Hard Start Technical Service Bulletin

Rev A: 8 June 2017B

P/N: TB17.001

Effected units: WD120 Series Water-to-Water

Figure 1: Second Compressor Contactor

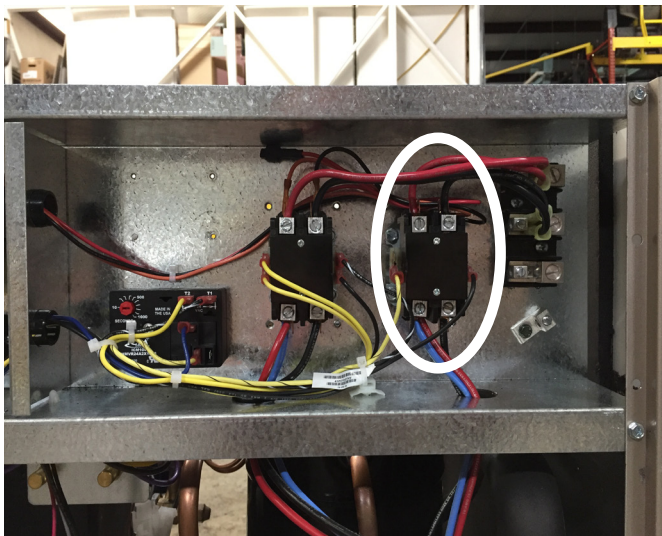
2. Remove the "T" side of the harness from the contactor. (Figure 1)

5. Reconnect the compressor harness back to the contactor as originally wired. (Figure 1)
